N60 Breaffy Active Travel and Safety Measures Scheme

Stage 1 Road Safety Audit Report

Issue 1 - August 2022

Document No: N60BA-ROD-GEN-SW_AE-RP-CH-301001 P02

Figure 6.1: Entry Path Curvature at IDA Roundabout.

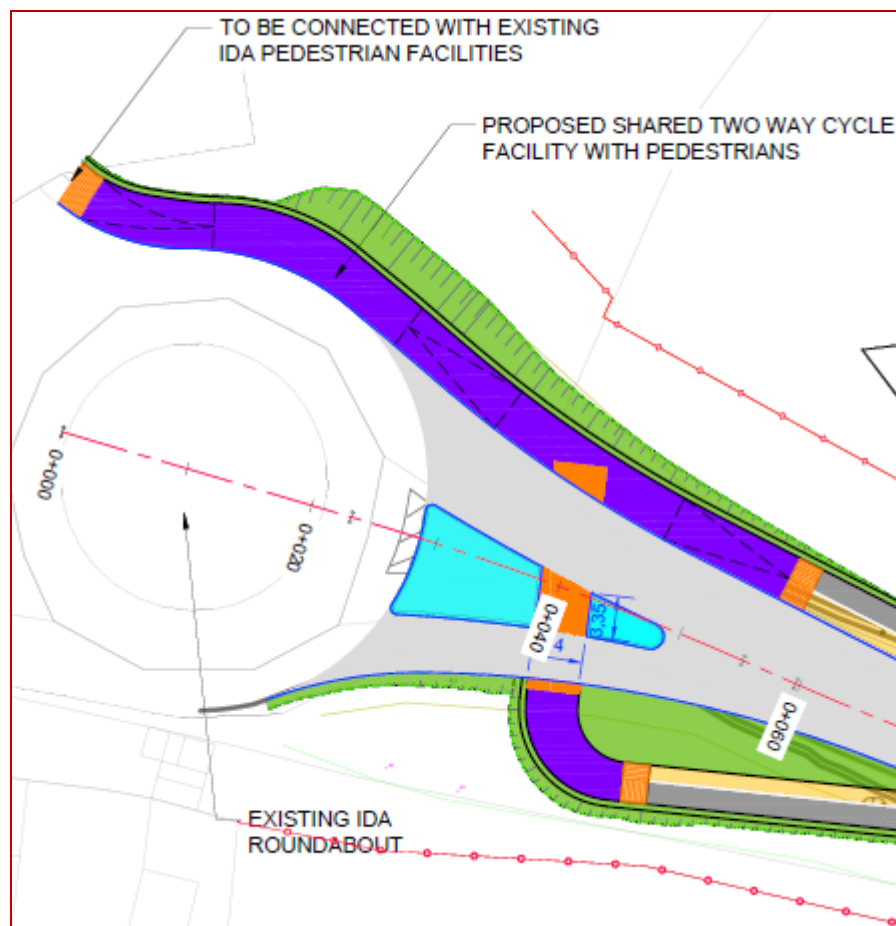
Drawing No. N60BA-ROD-HWY-SW_AE-DR-CH-30051 Rev.P01, it appears that the size of the splitter island has been increased on the eastern arm approach to the roundabout which could reduce the entry path curvature for vehicles travelling westbound along the N60 approaching the roundabout. This could result in high approach speed which could increase the likelihood of collisions between vehicles entering the roundabout and vehicles on the circulatory carriageway.

Care should be taken during the development of the design to ensure that adequate entry path curvature is provided.

6.1	Yes	Yes		
6.2	No	Yes	The proposed design solution is following DN-GEO-03060, giving priority to the cyclists. The shared facility pavement is carried across the entrance with coloured surfacing to highlight the conflict area. The vehicle access is at the same level as the shared facility. Marking will be included at detailed design.	Yes

Figure 6.5: Example of inadequate lateral separation between N60 carriageway and cycle facility

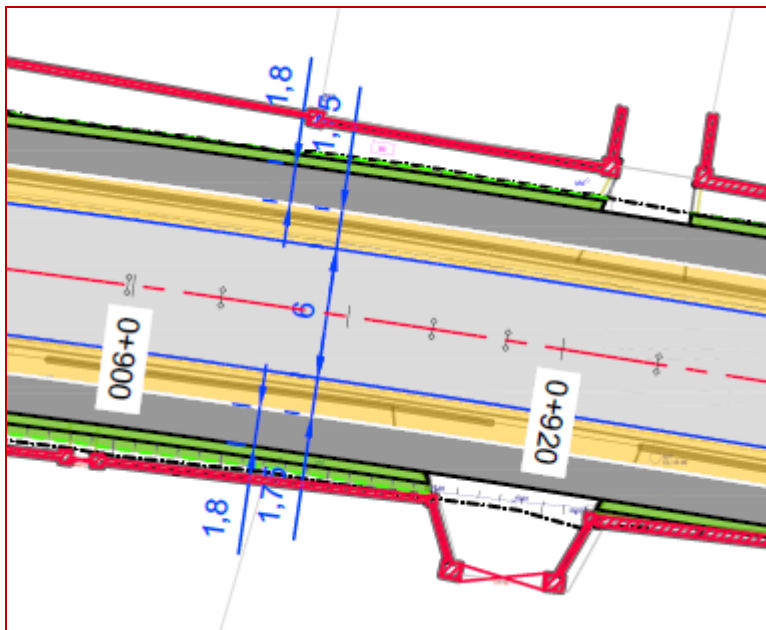
The drawings indicate that there are locations along the scheme where adequate lateral separation does not appear to be provided between the one-way cycle facility and the N60 carriageway, which could lead cyclists to unintentionally entering the carriageway, increasing the likelihood of cyclists colliding with vehicles travelling along the N60 which could result in serious injury to the cyclist.

Adequate lateral separation should be provided between the N60 carriageway and the cycle facility along the full extent of the scheme.

6.5	No	No	Adequate lateral clearance has been provided, which in this 60kph zone is provided in accordance with the Design Manual for Urban Road and Streets and the National Cycle Manual. The 1.75m cycle facility is made up of 1.25m single file + overtaking cycle track with 0.5m outside edge against a raised kerb.	Yes
6.6	Yes	Yes		
6.7	Yes	YES - Tactile paving and dropped kerbs have been provided throughout the scheme but are not shown on the general layout drawings submitted for stage 1 audit.		
6.8	Yes	Yes - Signage to be addresses at Detail Design		
6.9	Yes	Yes		
6.10	Yes	Yes - Signage and marking to be addresses at Detail Design		
6.11	Yes	Yes - Signage to be addresses at Detail Design. Gateways not proposed.		
6.12	Yes	Yes		
6.13	Yes	Yes - Signage and marking to be addresses at Detail Design

Figure 6.6: Typical Layout of One-Way Cycle Facility Crossing at Direct Accesses and Junctions

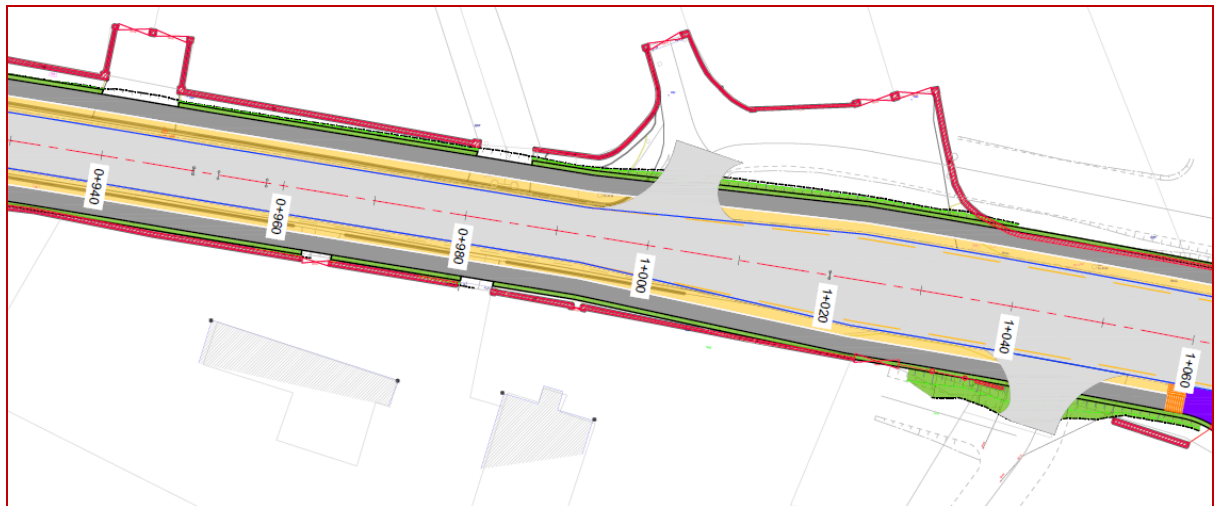
The drawings indicate the one-way cycle facility continuing across the mouth of direct accesses at various locations, and it is unclear if priority lies with the cyclists or with the vehicle on entry or egress to/from the direct access. This increases the risk of collision between vehicles entering and egressing the direct access and cyclists on the cycle facility crossing.

The cycle track pavement construction should be carried across the entrance to clearly indicate priority to cycle traffic. Cycle symbol road markings and additional paint lines should be provided to clearly indicate the presence of the cycle facility to motorists. Colour contrast could be provided along the cycle route warning cyclists of the upcoming conflict with motorised vehicles using the direct access. Adequate visibility splay should be provided so that drivers are aware of any oncoming cyclists.

Figure 6.7: Typical Layout of One-Way Cycle Facility Crossing at Priority Junction

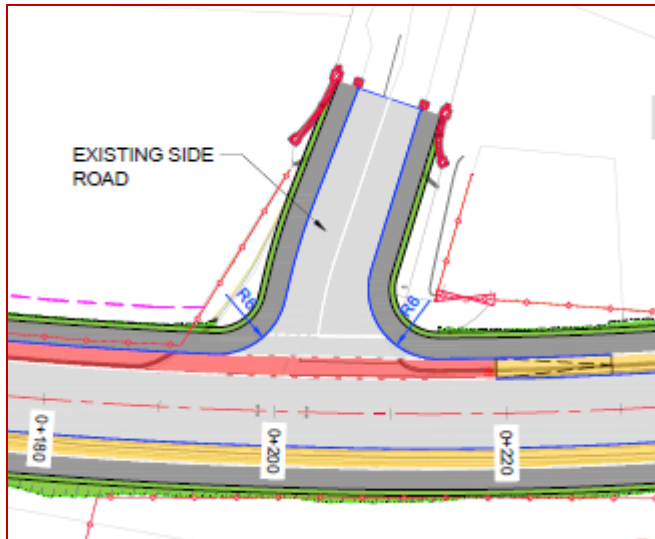
It is noted from the drawings that tactile paving is not indicated at the crossing point at various priority junction locations along the scheme. It is unclear if dropped kerbs are provided at the crossing point. This could increase the likelihood of visually impaired pedestrians being unaware of the presence of the junction and unintentionally entering the carriageway and colliding with vehicles, which could result in serious injury to the pedestrian.

Care should be taken during the development of the design to ensure that appropriate tactile paving and dropped kerbs are provided throughout the scheme.

Figure 6.10: Kilkenny Cross Roundabout – Reconfigured Layout with New Pedestrian & Cyclist Facilities

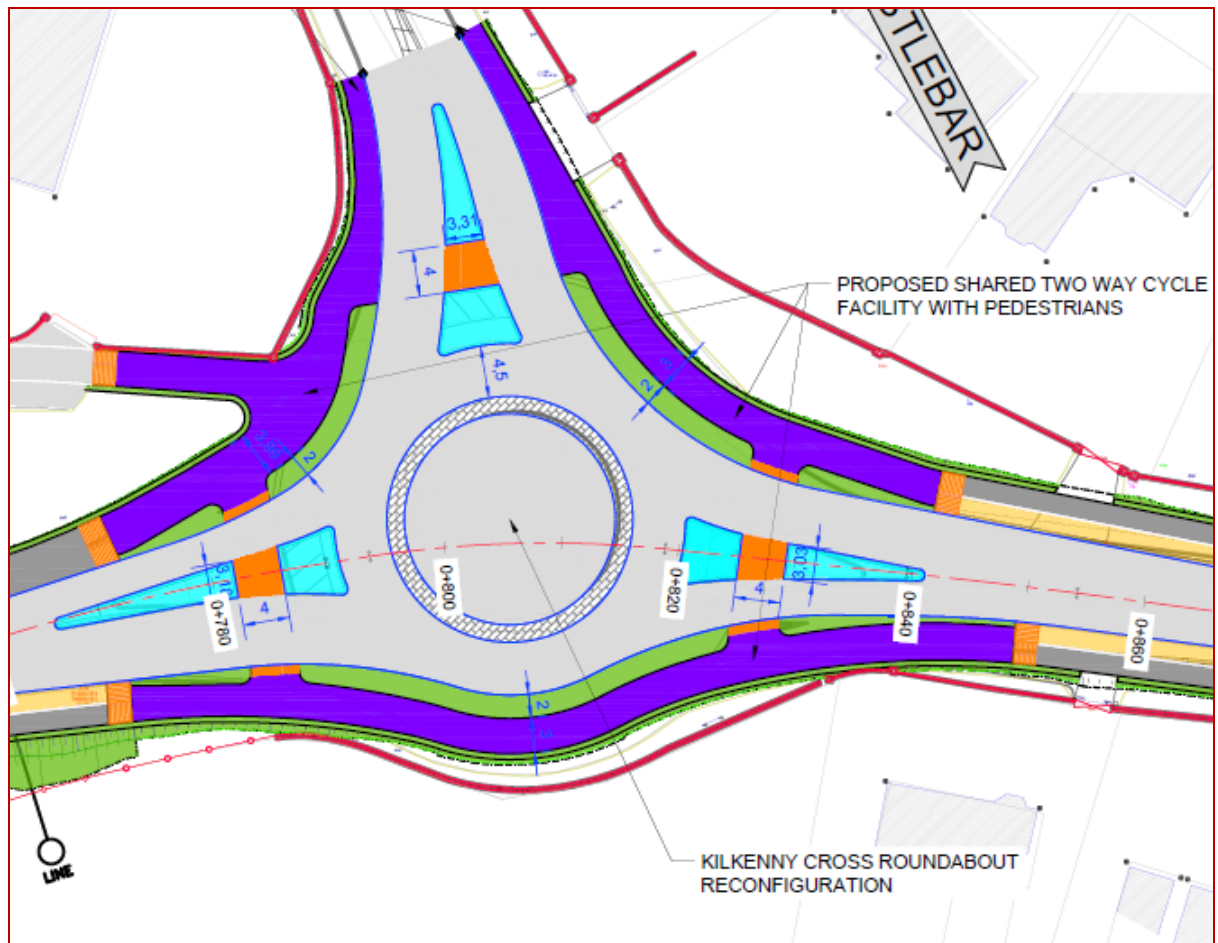
The drawings provided indicate that the layout of the roundabout with segregated cycle facilities may not be consistent with other roundabout junctions in this area. It is unclear if the layout is readily understandable by cyclists in that they will need to use the crossing points at the splitter islands to travel around the roundabout. The typical roundabout layout in similar locations, cyclists are required to use the circulatory carriageway. This could increase the likelihood of collisions between cyclists and pedestrians / vehicles if cyclists fail to use the dedicated crossing points.

Care should be taken during the development of the design of the scheme at this roundabout junction to ensure the layout is clear to cyclists so that they understand the roundabout layout. Additional signing, lining and appropriate road markings should be provided to help cyclist understand the new layout.

Figure 6.12: Sharp Skew angle at junction Between N60 and Access Road

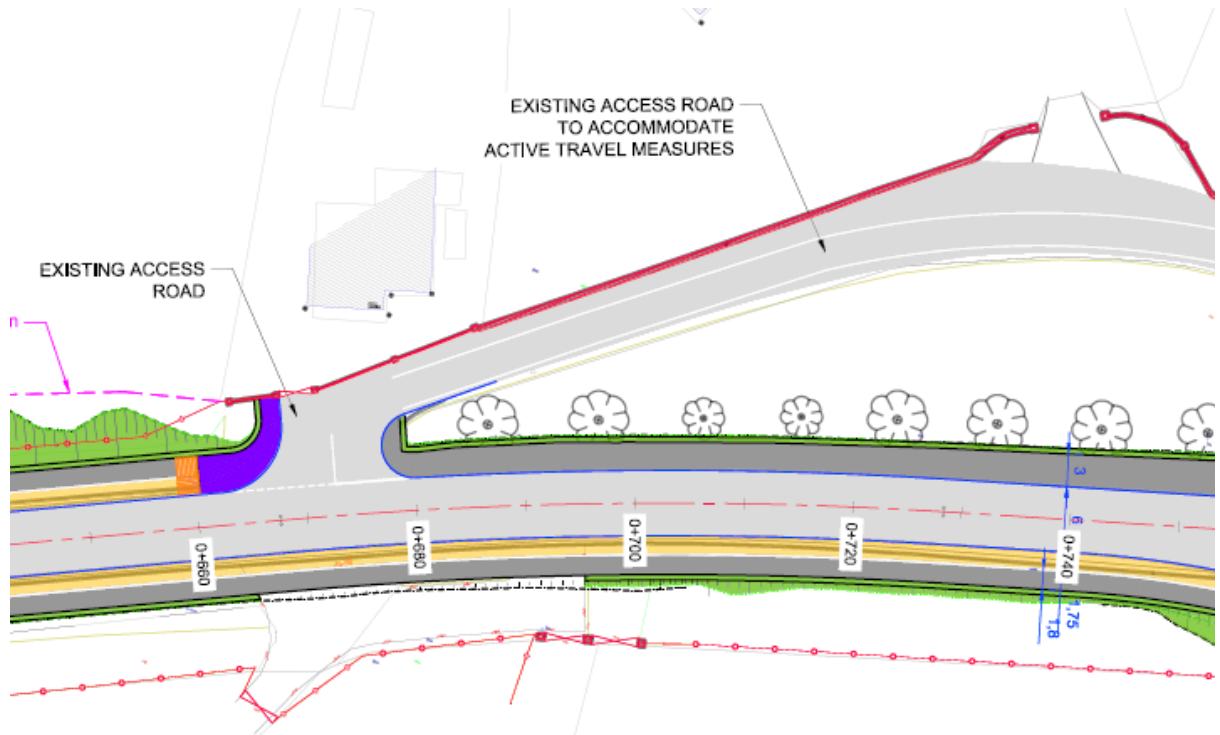
The drawings provided indicate that the bell mouth at the junction to the access road at Ch.670 has been tightened, with a corner radius of $R=2.5m$ provided at the eastern corner of the junction. It is noted that the access road is on a sharp skew angle approaching the junction with the N60. Should an insufficient swept path be provided to cater for turning requirements of HGV's and large vehicles turning left from the access road onto the N60 this could increase the likelihood of large vehicles over-running the footpath and colliding with pedestrians which could result in serious injury to the pedestrian. HGV's and large vehicles turning left from the access road may need to use the opposing lane to complete the turning manoeuvre which could

increase the likelihood of collisions with vehicles travelling westbound on the N60 in the opposing lane.

Care should be taken to ensure that the corner radius is adequate to cater for the turning requirements of HGV's and large vehicles.

Figure 6.15: Shared Area Link to Footpath at Kilkenny Cross Roundabout

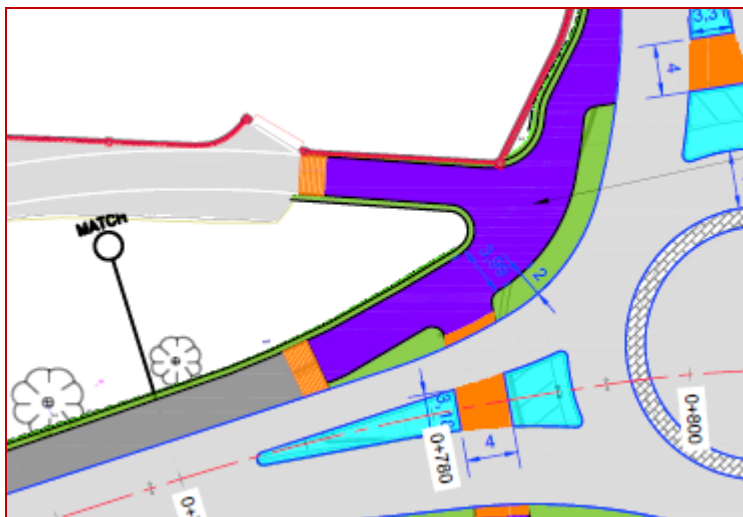
Drawing No. N60BA-ROD-HWY-SW_AE-DR-CH-30052 Rev.P01 indicates that the shared use area on the western side of the roundabout extends from the crossing point along the north side of the N60 to the proposed footpath. This could increase the likelihood of cyclists being directed towards the dedicated footpath and colliding with pedestrians.

Care should be taken during the development of the design to ensure that cyclists are provided with a clear route through the roundabout junction.

6.15	Yes	Yes- The section west of the crossing point to be clearly defined as pedestrian only with cyclists directed to the shared street.		
6.16	Yes	Yes

Figure 6.16: Direct Access at Kilkenny Cross Roundabout

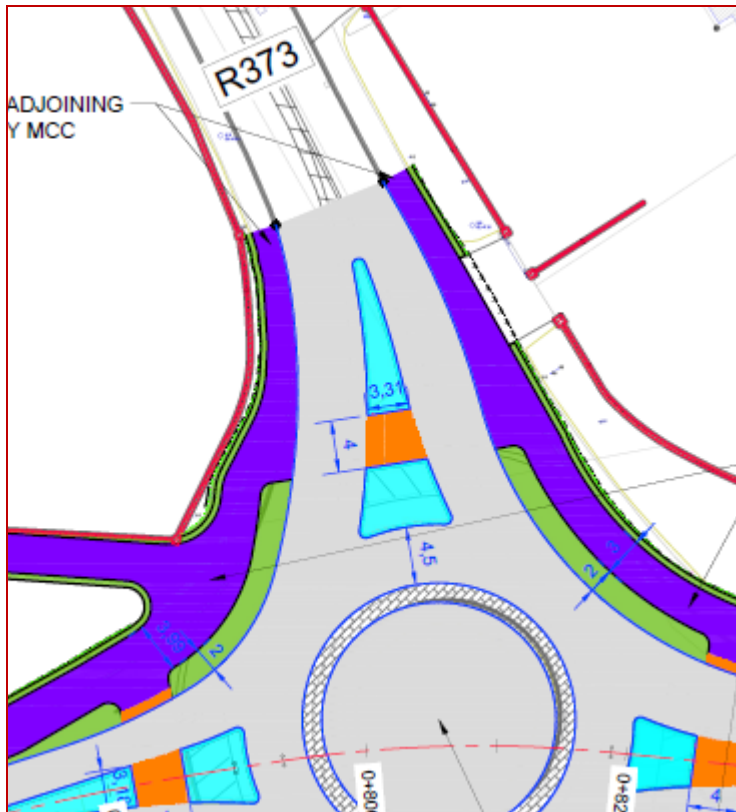
Drawing No. N60BA-ROD-HWY-SW_AE-DR-CH-30052 Rev.P01 indicates that a direct access is located near the roundabout along the northern arm. Drivers egressing from the direct access wishing to travel northwards on the R373 could attempt to turn right from the access and join the R373 beyond the splitter rather than turning left and using the roundabout then onto the R373. This could increase the likelihood of collisions between vehicles travelling south on the R373 approaching the roundabout and a vehicle exiting the direct access turning right onto the R373.

Care should be taken during the development of the design to prevent a driver egressing the direct access to turn right onto the R373. A no-right turn sign should be

provided opposite the direct access and the length of the splitter should be increased to prevent right-turning from the direct access.

Figure 6.18: Example of Taper along N60

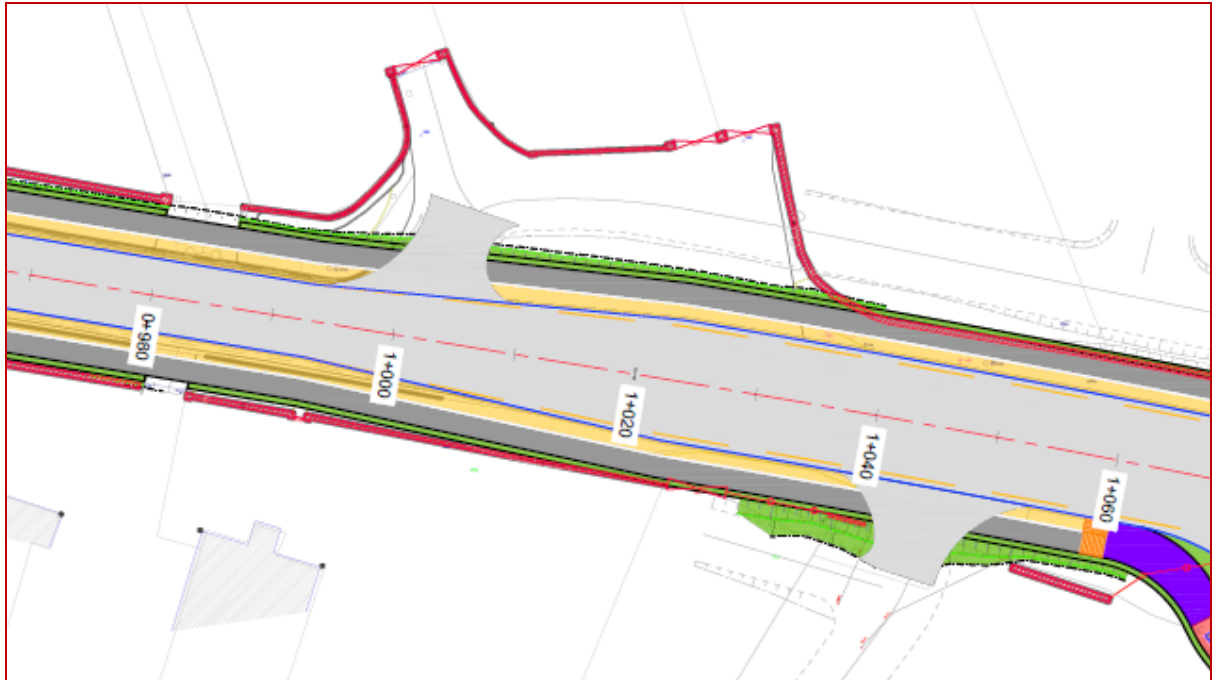
The drawings provided indicate that the proposed road widths narrow, and it is noted that the taper rates appear to be sharp at various locations along the scheme. This could increase the likelihood of drivers colliding with the kerb at the narrowing sections, particularly at night.

Care should be taken during the development of the scheme to ensure that a smooth transition in road width is provided at these locations. Warning signs should also be provided to inform drivers that the road narrows ahead.

6.17	Yes	Yes		
6.18	No	No	The tapers relate to the development of right turn pockets and the introduction of hard strips through the grade separated junction. The layout will be clear once the road markings are in place. Road narrows signs would not be appropriate.	Yes – Care should be taken in the development of the road markings design to ensure appropriate tapers are provided.

Figure 6.19: Example of Central Island at Bend Out Crossing

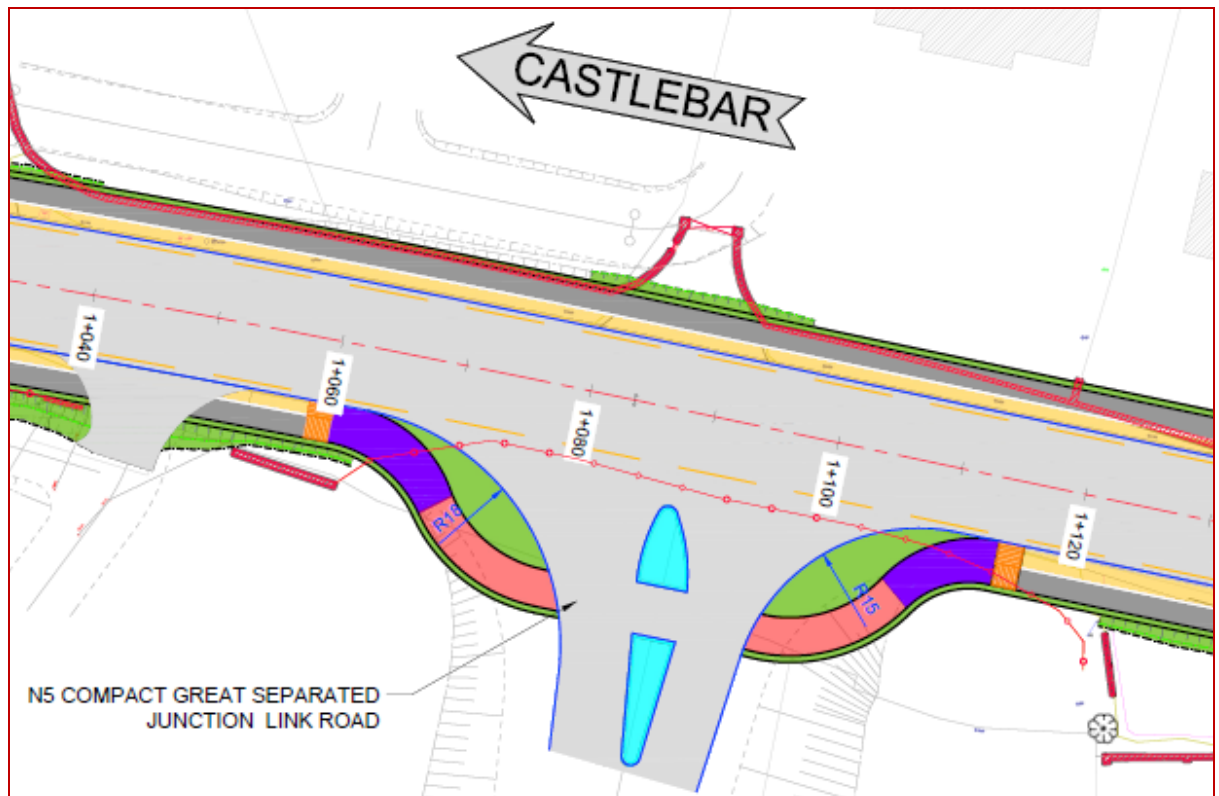
The drawings provided indicate a bend out crossing with a central island at priority junctions at various locations along the scheme, however, the proposed layout of the central island including road markings is not consistent with Figure 5.9 Bend Out Crossing with a Central Island shown in TII Publications DN-GEO-03060. This could increase the likelihood of vehicles colliding with pedestrians and cyclists using the crossing.

Care should be taken during the development of the scheme to ensure that the central island at bend out crossings is safe for use by pedestrians and cyclists.

6.19	No	No	Proposed islands are sized to meet the requirements of both DN-GEO-03060 and DN-GEO-03043. Signage and marking to be addresses at Detail Design	Yes

Figure 6.20: Existing Layout at Priority Junction at Local Road L5757

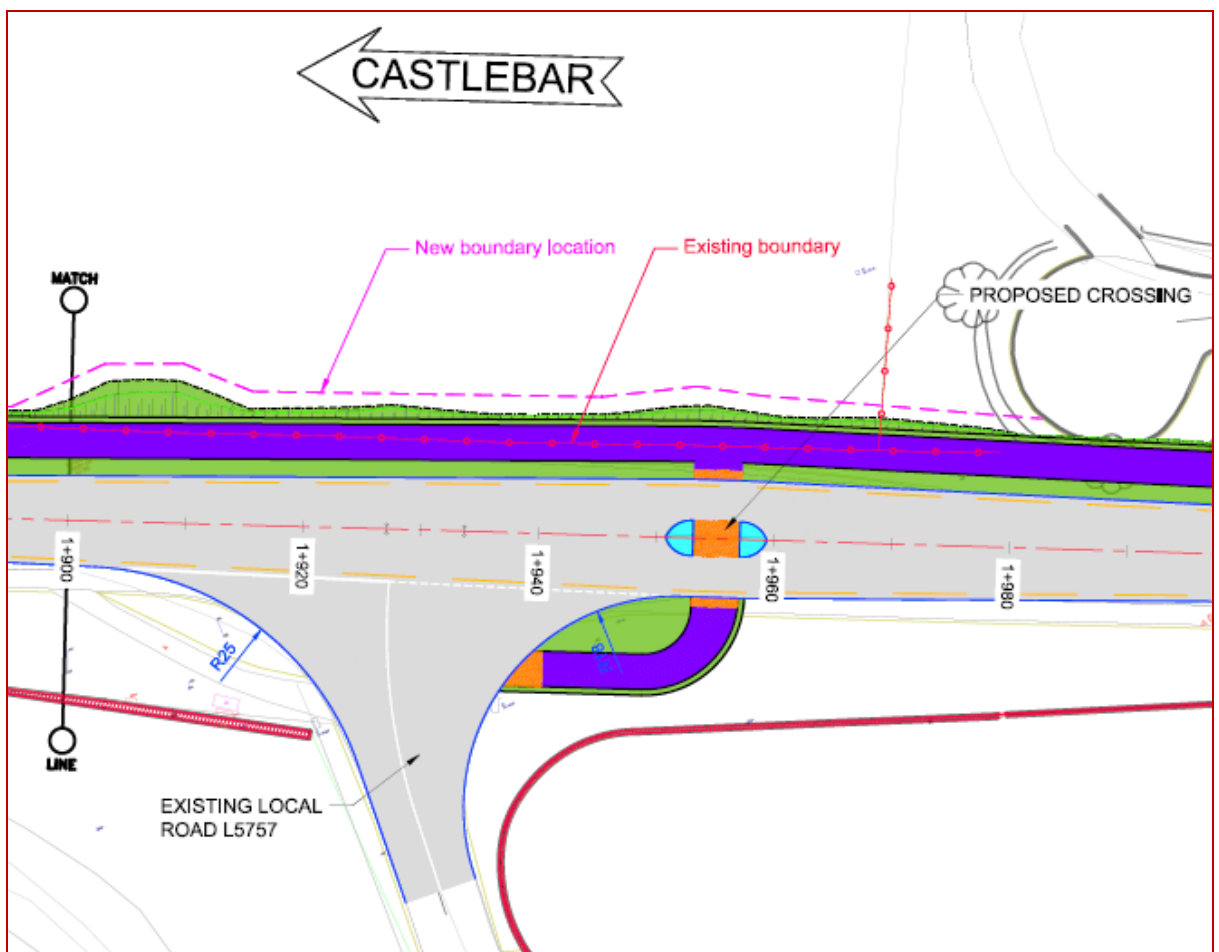
Drawing No. N60BA-ROD-HWY-SW_AE-DR-CH-30053 Rev.P01 indicates that a new crossing point for pedestrians and cyclists is located adjacent to Local Road L5757, however, it is unclear if the crossing point is linking to an existing footpath on the southern side of the N60. If a pedestrian / cycle facility is not provided at this location this could increase the likelihood of pedestrian and cyclists entering the carriageway at an inappropriate and unsafe location.

Care should be taken during the development of the scheme to ensure that a pedestrian / cycle facility is provided on the southern side of the N60 at this location, linking to the crossing point. If it is not intended to provide a pedestrian and cycle facility, the provision of the new crossing point should be relocated.

6.20	Yes	No	It is not intended to provide a pedestrian and cycle facility on the south of the N60. The existing short section of footpath west of the junction will be removed to avoid confusion. The crossing is provided to connect housing on the L5757 to the new facility and has been located to be consistent with previous recommendation that this should be on the right of the junction.	Yes
